# ***Interactive comment on* “Examining cross-scale influences of forcing resolutions in a hillslope-resolving, integrated hydrologic model” by Miguel A. Aguayo et al.**

Received and published: 3 February 2021

**Fig. 1.** Example of 30 m atmospheric resolution applied to a 90 m land surface resolution.

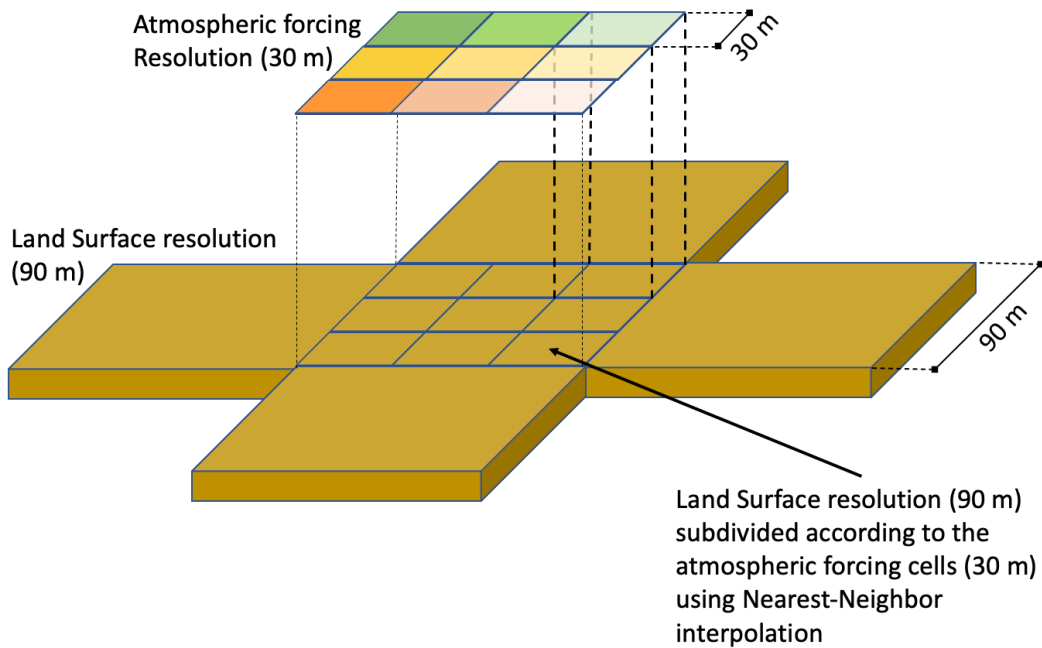
An example of how we performed the experiments is when using 30 m atmospheric resolution applied to a 90 m land surface resolution. Here, we subdivide the surface

cell into 30 m pieces by using nearest-neighbor resampling method in order to maintain the values of the 90 m land surface cells intact as shown in Fig 1. To clarify this point, we will provide a more elaborated paragraph to explain the interpolation process in both atmospheric and surface resolutions.
